Groundwater Application Review Summary Form

Application # G- 18805 RR

PUBLIC INTEREST REVIEW FOR GROUNDWATER APPLICATIONS

SUBJECT: Application G- 18805 Supersedes review of June 14, 2019
Date of Review(s)

Hydrograph of Nearby Wells

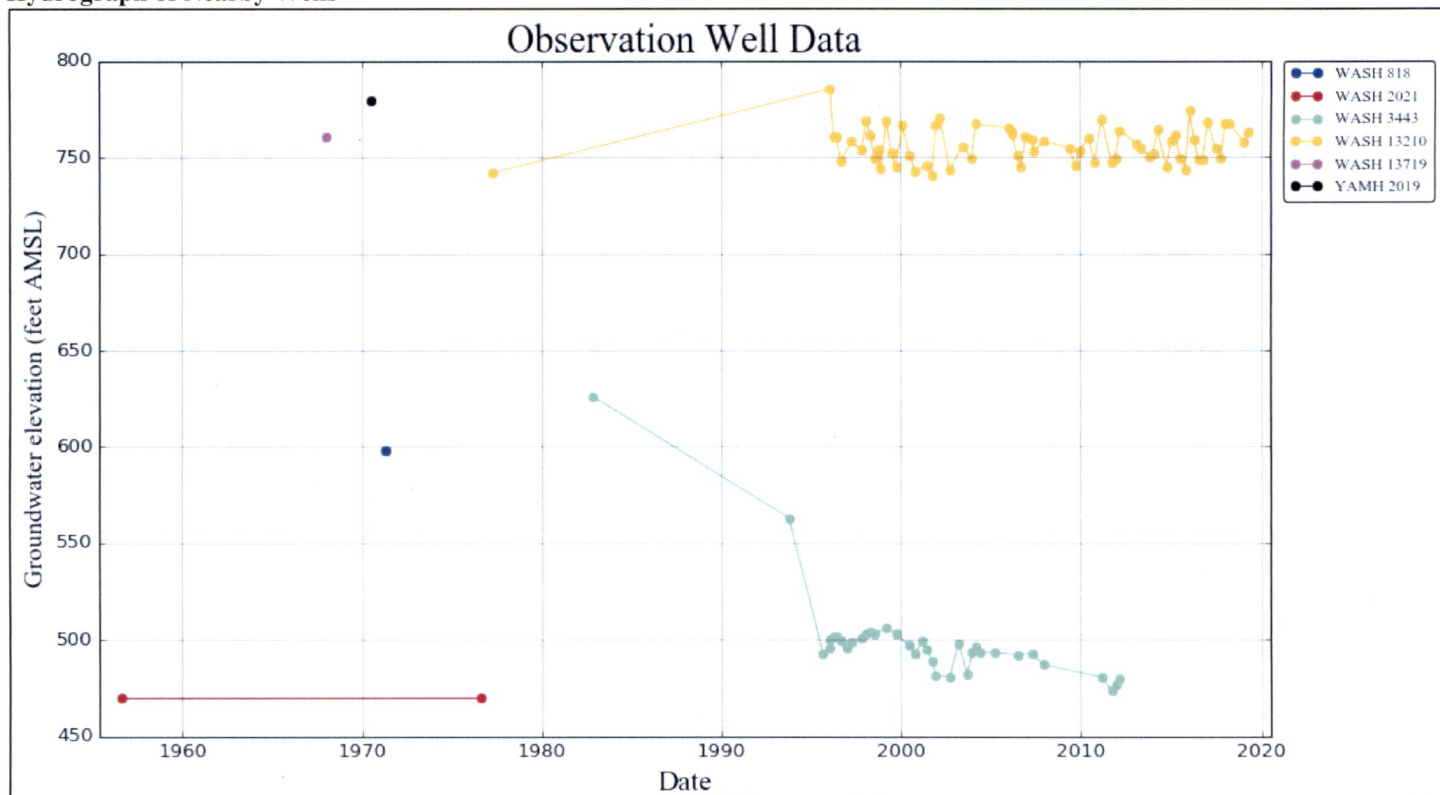
Based on nearby well logs there appear to be at least two distinct basalt aquifers in this vicinity (see hydrograph below). Shallower wells (completed to elevations of approximately 600 feet or higher above sea level (asl)) have water elevations around approximately 760 feet asl (see WASH 13210, WASH 13719 and YAMH 2019 in the hydrograph and comparative lithology below). It appears that the local streams intersect this aquifer. Deeper wells have water elevations around approximately 500 feet asl (see WASH 3443, WASH 808 and WASH 2010 in the hydrograph and comparative lithology below). The applicant's well needs to be constructed so that it is only completed in the lower basalt aquifer to avoid hydraulic connection with the nearby streams.

1. Groundwater production in the well shall be limited to a single aquifer in the Columbia River Basalt Group.
 - a. The well shall be continuously cased and continuously sealed into hard dense basalt at a depth of 75-100 feet below the local level of stream incision. Downstream, within a mile of the proposed well location the stream bed elevation of Chicken Creek and its tributaries reaches an elevation of approximately 360 feet above mean sea level (amsl). For the proposed well location, with a land surface of approximately 770 feet amsl, this means the well must be **continuously cased and continuously sealed into hard dense basalt at a depth of approximately 470-480 feet below land surface** to protect the surface water sources.
